Work Order ID 114636

Item Name: Aft Crosstube - High

DART AEROSPACE LTD		Work Order:	114636
Description: Crosstube High Aft (412)		Part Number:	D412-664-203
Inspection Dwg: D412-664-243 Rev: E		Page 1 of 1

DRAWING NO. D412-664-243	TITLE CROSSTUBE ASS'Y (412 HI AFT)	REV. E	DART AEROSPACE LTD ENGINEERING ORDER		D.E.O. NO. D412-664-243-E-2	SHEET NO. SHEET 1 OF 1	SCALE NTS
DRAWN <i>MP</i>	CHECKED <i>AS</i>	MFG. APPR. <i>R</i>	APPROVED <i>MP</i>		DE APPR. <i>#</i>		
DATE 11.09.07	DATE 11.09.19	DATE 11.09.19	DATE 11.09.19		DATE 11.09.19

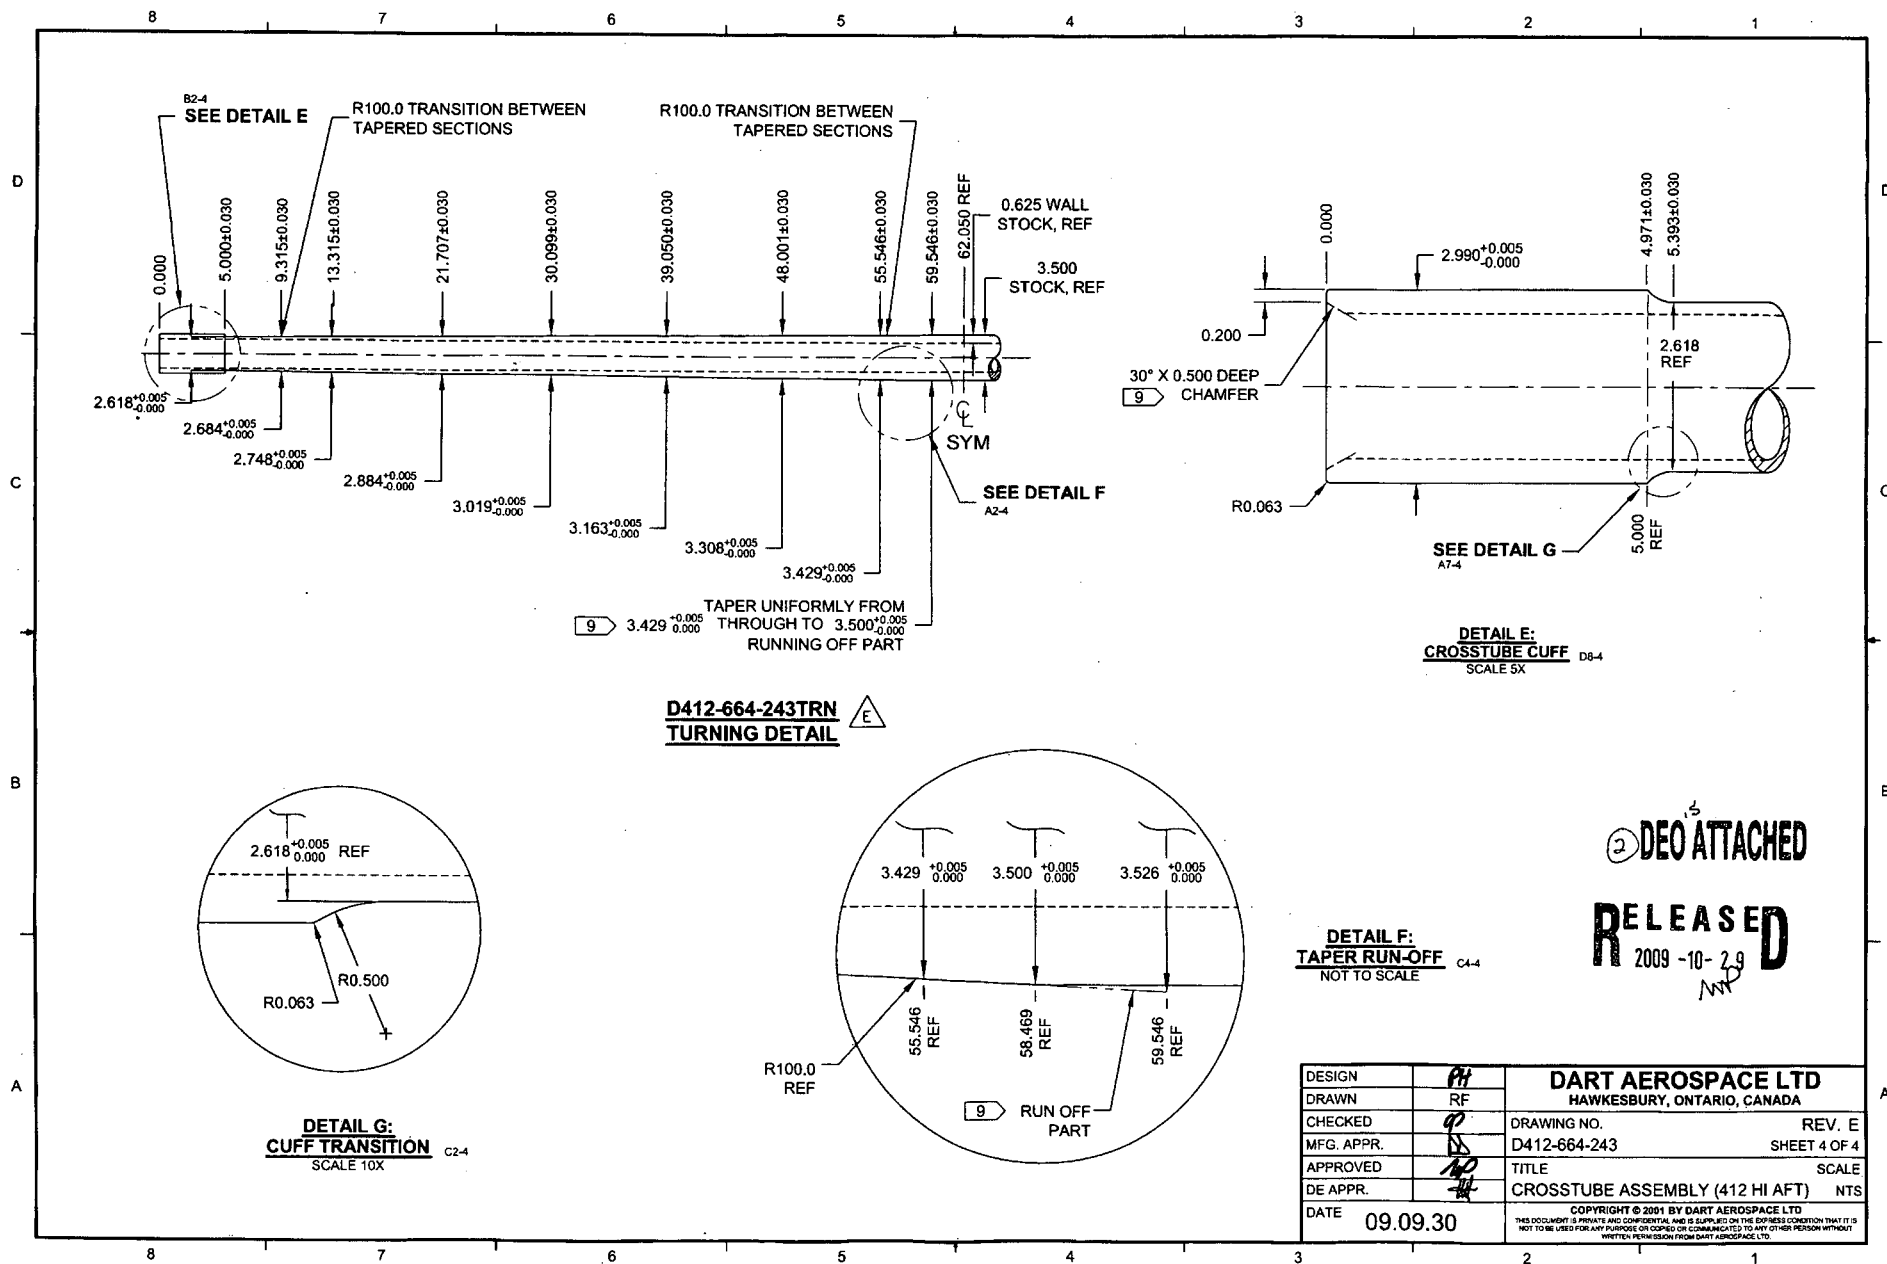
**PURPOSE:**

REPLACE MAGNOBOND WITH 3M DP460 SCOTCH-WELD EPOXY ADHESIVE

NOTE 12 & 16, SHEET 1 IS AMENDED AS FOLLOWS:

DRAWING NO. D412-664-243	TITLE CROSSTUBE ASSEMBLY (412 HI AFT)	REV. E	DART AEROSPACE LTD ENGINEERING ORDER		D.E.O. NO. D412-664-243-E-4	SHEET NO. SHEET 1 OF 3	SCALE NTS
DRAWN 92	CHECKED A	MFG. APPR. A	APPROVED MP		DE APPR. MP		
DATE 12.08.21	DATE 12.08.30	DATE 12.08.30	DATE 12/8/30		DATE 12.08.30

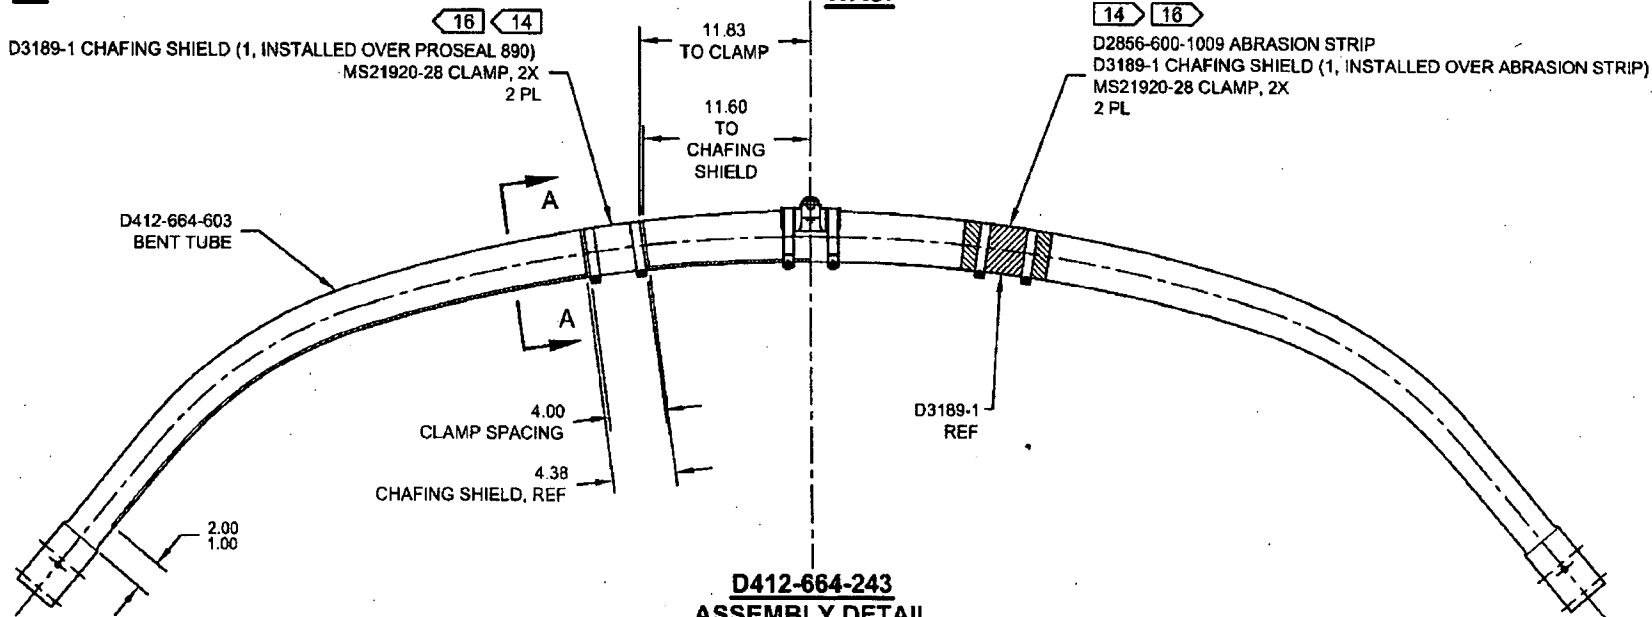
**NOTES 2, 14, AND 16 ON SHEET 1 ARE AMENDED AS FOLLOWS:**

**WAS:**

- 2) FINISH: CHEMICAL CONVERSION COAT PER DART QSI 005 4.1  
PRIME INSIDE AND OUTSIDE PER DART QSI 005 4.2  
PAINT OUTSIDE PER DART QSI 005 4.2
- 14) INSTALL D2856-600-1009 ABRASION STRIPS WITH A 0.13 REF GAP ON BOTTOM SIDE OF CROSSTUBE PER QSI 035.
- 16) TORQUE CLAMPS 80 TO 100 IN-LB. ENSURE AT LEAST 1.5 THREADS SHOWING IN SAFETY AND THAT NUT HAS NOT BOTTOMED-OUT AFTER TORQUING.
